# Addendum 01

**Project #:** 1347-23

Mechanical Upgrades  
Heat Pumps & Boilers

**Purpose: Addendum 01**

**PARTIAL MECHANICAL FLOOR PLAN UNIT 'A'**  
 SCALE: 1/8" = 1'-0"

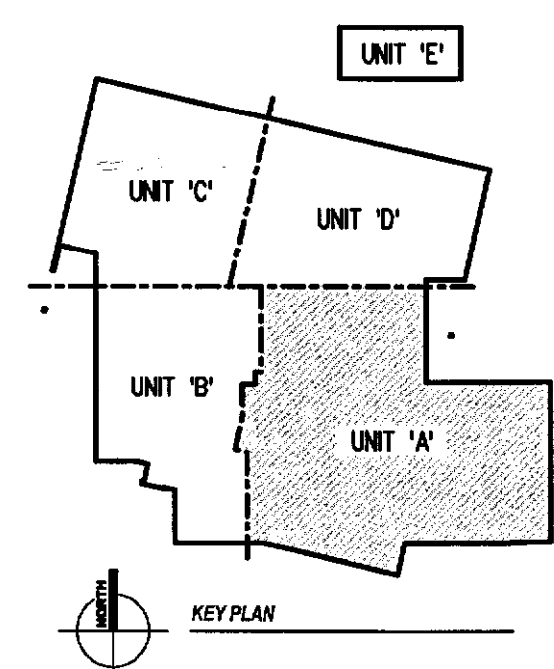
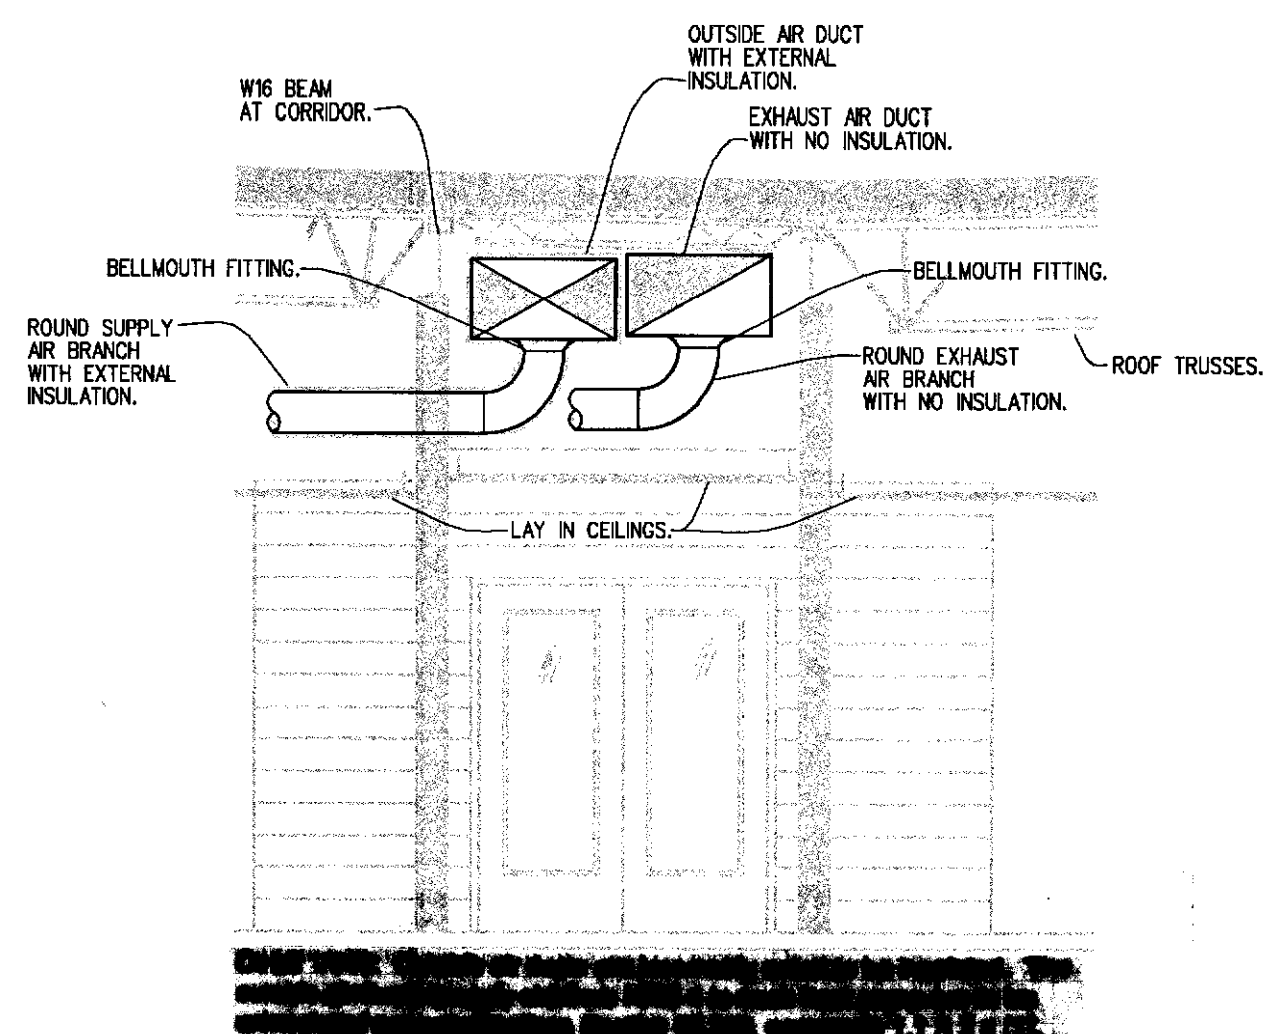
- ADD #3**  
 ELIMINATE HRU-7  
 Add unit HRU
- A. Eliminate HRU-7 from the Greenhouse, including louvers L-3 and L-4 and all ductwork associated with the heat recovery unit.
  - B. Furnish and install unit heater equal to Trane model 42-S, 591 cfm, 15.0 MBH @ 1.5 gpm (20F WTD), 1550 rpm, 1/20 hp, 120V/1/60. Install in the same general location where HRU-7 is shown on the plans.
  - C. Furnish and install a new exhaust fan in the Greenhouse, next to fan EF-3. New fan shall be Greenheck model SP-5 or equivalent, nominally 50 cfm, 120V/1/60, 46 watts, with wall discharge cap. Operate directly from a room humidifier to remove humid air (makeup air is intended to be provided by leakage). No CO2 monitoring or control function required.
